PART V | 'AS BUILT' / EXISTING

107 HIGH STREET, LINDFIELD, HAYWARDS HEATH, RH16 2HR

PART VI | COMPARISON DRAWINGS

PART VII | PROPOSED REGULARISATION
OF SCHEME

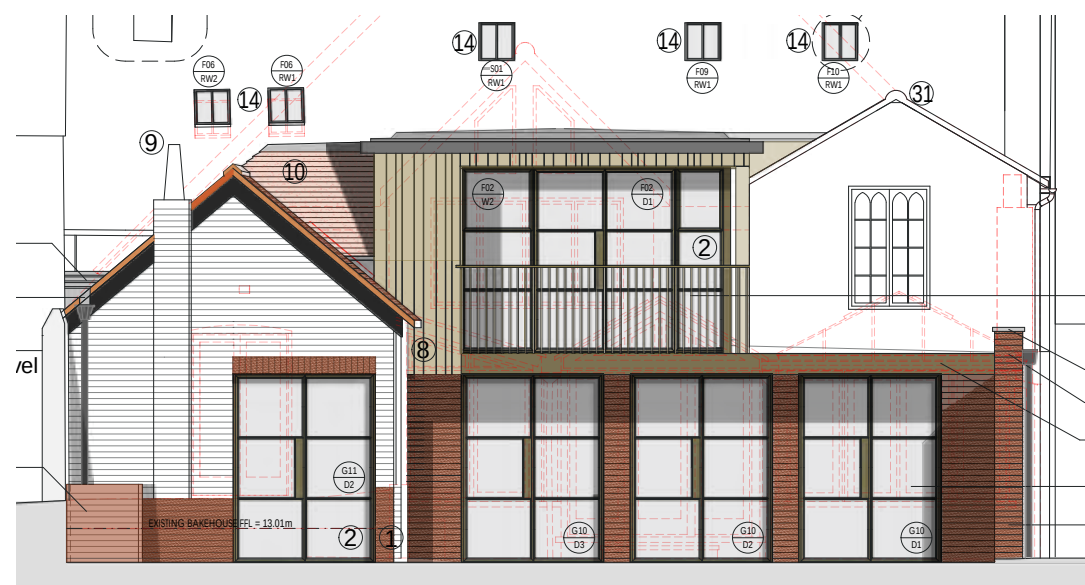
The rear extension has been constructed in general accordance with the original submitted scheme, which was later amended and resubmitted in March 2023 under application numbers DM/22/3694 & DM/22/3695. The adjacent drawing extracts illustrate the rear elevation of the original scheme (figure 1), amended and approved scheme (figure 2) and 'as built' scheme (figure 3).

The original comments received from the Heritage Officer expressed concerns regarding the original proposal for the rear extension. As the building has been constructed in general accordance with the original scheme, these comments are reconsidered for the purpose of this application.

The following comments were received from the Heritage Officer regarding the original design of rear extension:

- *The existing rear extensions are modern in date- their removal is not considered contentious in principle.*

- *Although I do think there is scope for the replacement/ reconfiguration of the existing rear additions, the proposal as shown raises concerns in terms of bulk, form, detailed design and materials. At ground floor the footprint of the proposed replacement addition is reduced in comparison to the existing. However, at first floor the extension is both wider and deeper, resulting in increased apparent bulk notwithstanding the reduced roof height- this will be particularly apparent in views from the side, and in particular from the south. The boxy form of the extension with extensive flat roofing will exacerbate this affect, and is unsympathetic to the historic roof form of the building and to the character of the wider area. The elevational treatment, with the recessed balcony with a large glazed opening, and the different facing material at first floor, all serve to further draw attention to the first floor and enhance its undue visual prominence.*

- *The proposed rear addition also raises concerns in terms of its internal layout- one of the more positive features of the existing modern ground and first floor additions is that they exhibit a relatively ‘light touch’ in terms of the interface with the original rear elevation of the building, which remains visible internally. The proposal shows partitioning to the north eastern corner of the extension adjacent to the original rear elevation to create a pantry and utility at ground floor and a bathroom at first floor. This compartmentation of the space will adversely affect, if not remove, the current appreciation of the height and framing of this part of the rear elevation, an affect which will be compounded by the placement of features such as a shower cubicle against the wall. This aspect of the proposal is also considered to adversely impact the special interest of the proposal and how it is appreciated.*

- *The proposed extension involves the substantial loss of the fabric of the existing c.1830 rear two storey wing, with the internalisation of what little remains. In my opinion, which is broadly consistent with the commentary given within the Heritage Statement, this wing is of historical and architectural interest as an integral part of the 19th century alterations to the property, a key phase in its development, and contributes positively to its narrative. It is also an attractive and characterful feature of the rear elevation, in particular the original window and brickwork. For these reasons I consider that the extensive and destructive works proposed to this element of the building are contentious in principle. I do not consider that the internalisation of the first floor rear façade of the wing as a ‘feature’ within the bedroom space created will sufficiently preserve its interest.*

RESPONSE: Removal of rear extensions approved

RESPONSE: Analysis of the ‘as-built’ rear extension further into this chapter addresses design concerns

RESPONSE: The ‘as built’ ground floor layout closely matches the layout of the approved scheme, introducing the compartmentalisation for utility/pantry in the north-eastern corner of the extension. It is considered ‘light-touch’ and to be in accordance with approved scheme.

RESPONSE: The original gabled rear wing on the building is retained. It is partially visible on the rear elevation and its historic plan form is retained and legible in the new extension. The approved scheme allows the demolition of the ground floor element of this wing, diluting the plan form at this level, so retaining it and internalising it at first floor ensures the legibility of the plan form relating to this early 19th century wing is retained.

It is proposed for the historic brickwork wall and Victorian window to be made good and exposed internally, celebrating the original features of the house. This is much the same as the west/ rear wall of the original 15th century elements of the dwelling. By following this design language, internalising the window is in fact in accordance with the design language already present in the house.
